Service Bulletin SB0050

Date: February 2003
From: Capstone Technical Support
Subject: Pressure Regulator Replacement – Model C30 Liquid Fuel

Pressure Regulator Assembly
(513771)

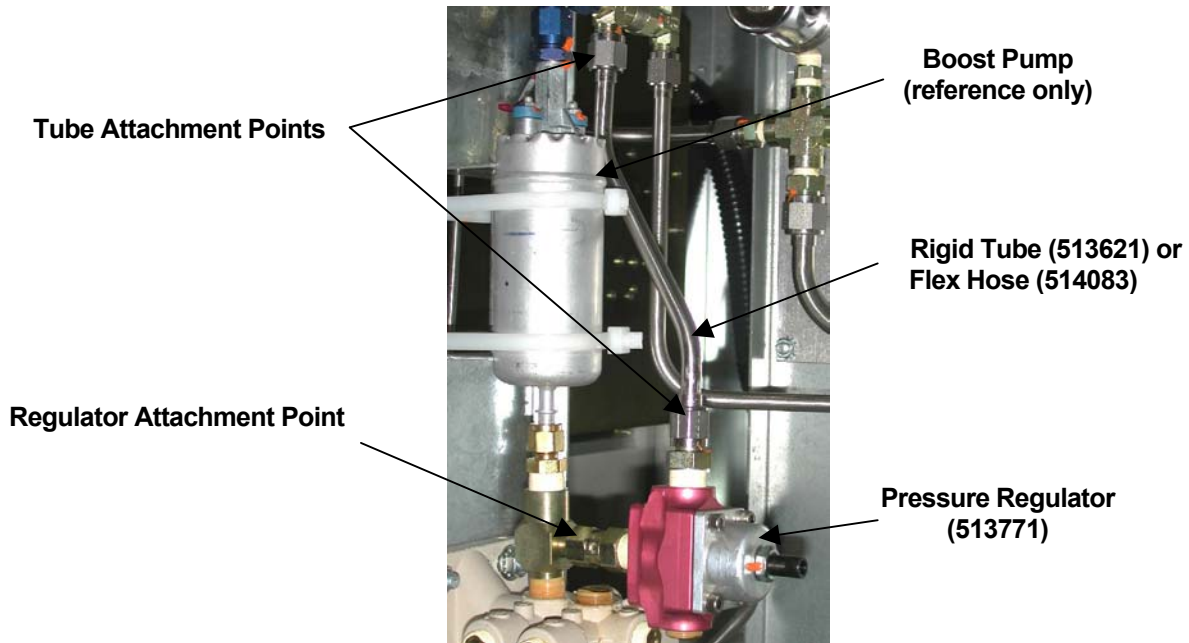
The Pressure Regulator currently installed on ELOR upgrades was found to be suspect for leakage through the body of the cap housing. This leakage occurs at the gasket interface between the regulator and cap housing. This small fuel leakage may prevent the filter assembly from performing as intended, as well as requiring occasional fuel cleanup.

As a recommended solution, Capstone is providing a kit containing the remanufactured pressure regulator, fittings, and flex hose. The flex hose (514083) is intended as a replacement part for earlier kits shipped with a rigid tube (513621).

4. Remove the 3/16-inch drain plug on side of regulator body (see location on page 1) to purge the return line and regulator of fuel.
